Toronto STAFF REPORT

Subject: Request for Direction Report
Site Plan Control Application 05 204361 NNY 25 SA
939 Lawrence Avenue East
The Cadillac Fairview Corporation
Don Mills Shopping Centre
Ward 25 – Don Valley West

Site Layout

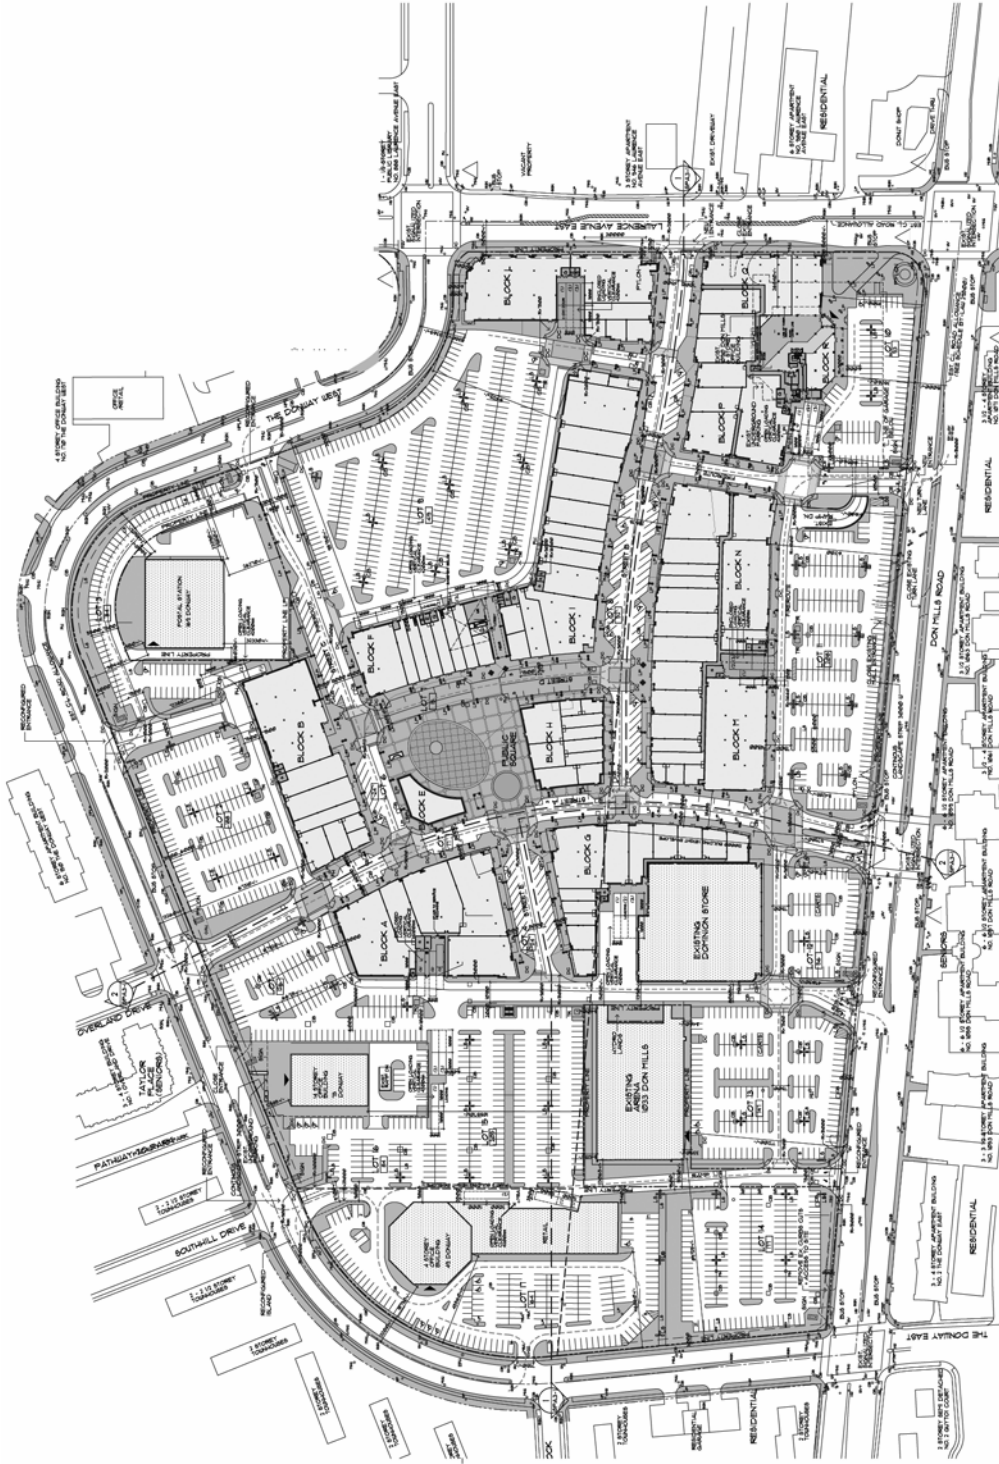
- (i) The following built form revisions shall be made to the site plan:
 - (a) the layout of the site should be reorganized by redeploying floor space to bring buildings with entrances up to the minimum 6m zoning setback along the Don Mills Road frontage with a priority given to the Lawrence Avenue corner and the north side of Street 'A' (east-west driveway);

- (b) the setback of the buildings along the Lawrence Avenue East frontage be increased from 1.5 to 3.0 metres to maximize opportunities for landscaping, seating and weather protection.

The proposed building footprints focus on the definition and support of the private internal street system rather than the public streets. As a municipal priority, building entrances should face public streets including Don Mills Road and Lawrence Avenue. The Lawrence Avenue frontage, currently developed with surface parking, proposes a strong built form presence with store fronts and entrances directly accessible to the public sidewalk. A similar built form approach should be taken on Don Mills Road, particularly at street corner locations. The following changes are recommended for the Don Mills Centre Site Plan to better meet existing policies:

1. the layout of the site should be reorganized by redeploying floor space to bring buildings with entrances up to the minimum 6m zoning setback along the Don Mills Road frontage with a priority given to the Lawrence Avenue corner and the north side of Street 'A' (east-west driveway); and,
2. the setback of the buildings along the Lawrence Avenue East frontage be increased from 1.5 to 3.0 metres to maximize opportunities for landscaping, seating and weather protection.

Transportation Services staff has identified a number of issues ranging from the lack of information provided on the submission to specific concerns with respect to the location and/or design of the 10 existing/proposed access points to the site, as well as, site circulation concerns. Staff is recommending the applicant submit revised plans and drawings and a revised Traffic Impact Study.

- So as not preclude the proposed east-west driveway (Street “A”) from becoming public, Transportation Services requires it be designed to maintain an 18.5m cross-section, whereby the minimum pavement width is maintained at 8.5m, integrating the street design with the context of the surrounding neighbourhood, to protect for a future public roadway. The proposed private roadway must be constructed to municipal standards;

- The proposed north-south road (Street B) shall be designed with a minimum pavement width of 8.5m, for consistency with the east-west road (Street A);

- The northerly driveway on Don Mills Road, proposed to be relocated further north of its current location, must be restricted to right-in/right-out movements only, to preclude future conflicts with the operations of the Don Mills Road and Lawrence Avenue East intersection and the proposed gap in the median along Don Mills Road must be closed;

- The driveway along Lawrence Avenue, proposed to be relocated further west of its current location must be restricted to right-in/right-out movements only. All left-turn movements from this access point will be prohibited. Revised plans should illustrate appropriate physical measures restricting the left-turn movements at the driveway;

- The row of angled parking spaces proposed along the west side 'Street C' are a concern and must be re-evaluated. Revised plans are required to demonstrate how these spaces will operate in conjunction with the flow of traffic. The revised submission will also need to incorporate traffic control measures to increase vehicle and pedestrian safety;
- The proposed loading areas must be re-evaluated. The location for the loading areas for buildings A, B, F, M/N, R, 49 and 75 The Donway West will result in loading vehicle manoeuvres conflicting with main driving aisles, parking spaces, internal intersections; and areas of high pedestrian activity. This situation will compromise safety of both vehicles and pedestrians, as well as the efficiency of loading operations;

Landscape Layout

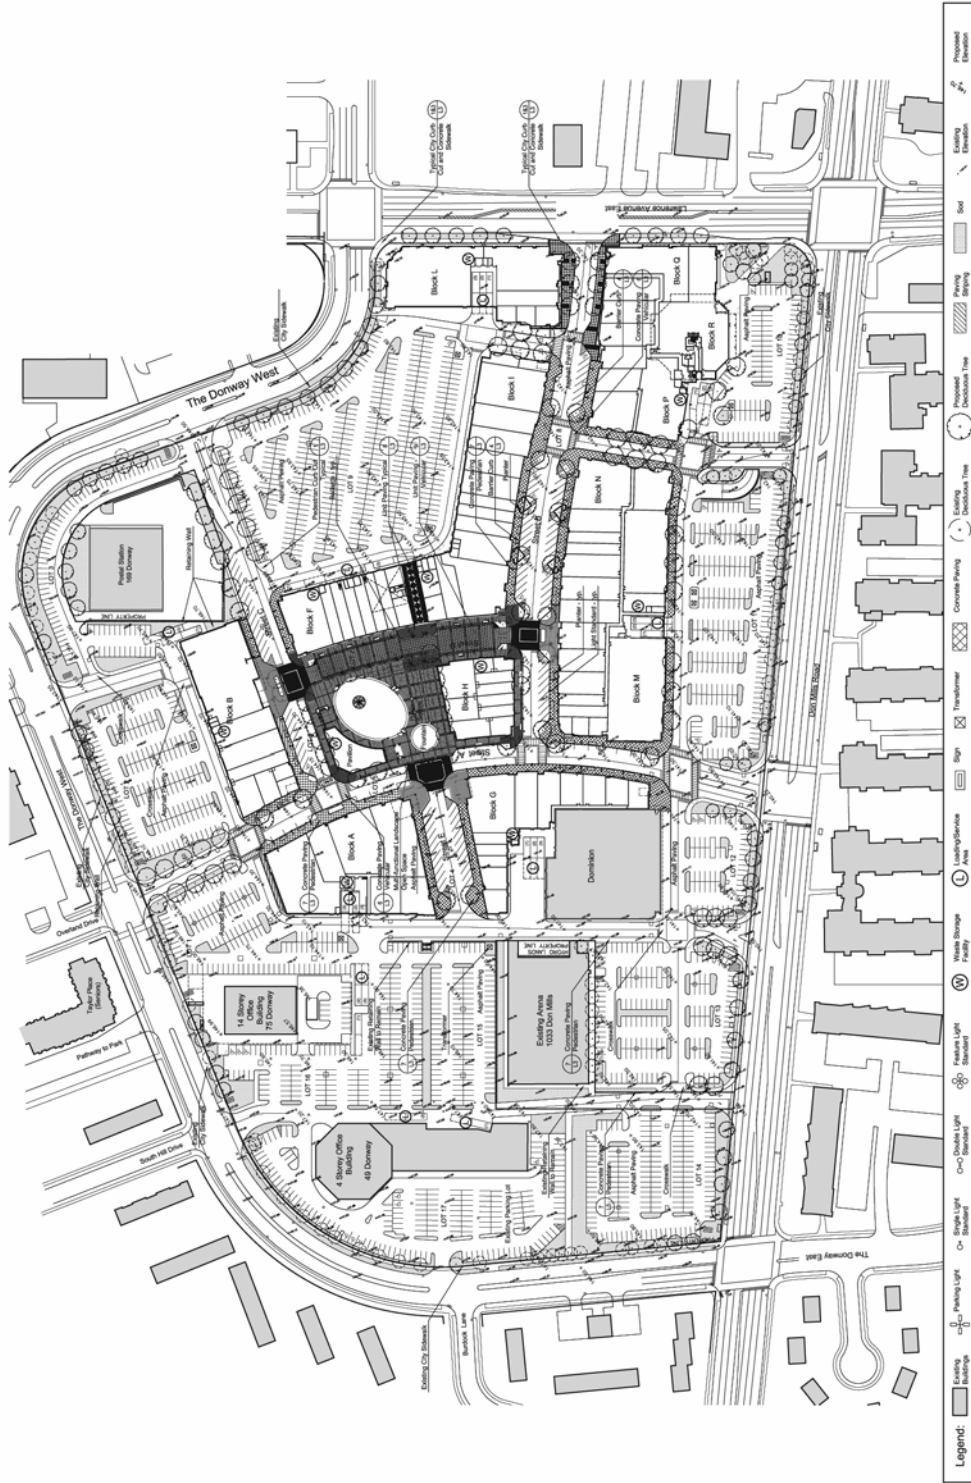
- (ii) Improvements to the landscape plans which include:
 - (a) a well defined landscaped edge along all parking areas that includes low shrub and perennial planting, high branching deciduous trees, evergreen trees, and a low wall or other repetitive landscape feature;

- (b) sufficient space along the storefronts to accommodate a high quality streetscape and public amenity including, but not limited to, weather protection, lighting, seating areas and street furniture, landscaping, trees, and decorative paving materials;

- (c) increased landscape areas within the parking lots;
 - (d) the open space at the southwest corner of Lawrence Avenue and Don Mills Road maintained, extended and enhanced;

- (e) loading and servicing areas integrated into the building mass, screened with landscaping, doors or other means from the existing public streets and new private circulation system; and,

- (f) a landscape terminus at the south end of the private driveway that runs south from the proposed town square (Street E').
 - (iii) A comprehensive pedestrian and cycling route plan that provides for:

To meet these objectives, improvements to the site landscaping is required. The applicant should be required to provide the detailed design of all site and streetscaping features to the satisfaction of the Director, Community Planning, North District. Improvements to the plan should focus on providing the following:

- a well defined landscaped edge along all parking areas that includes low shrub and perennial planting, high branching deciduous trees, evergreen trees, and a low wall or other repetitive landscape feature;

- sufficient space along the storefronts to accommodate a high quality streetscape and public amenity including, but not limited to, weather protection, lighting, seating areas and street furniture, landscaping, trees, and decorative paving materials;

- increased landscape areas within the parking lots;
- the open space at the southwest corner of Lawrence Avenue and Don Mills Road maintained, extended and enhanced;

- loading and servicing areas integrated into the building mass, screened with landscaping, doors or other means from the existing public streets and new private circulation system; and,

- a landscape terminus at the south end of the private driveway that runs south from the proposed town square (Street E’).
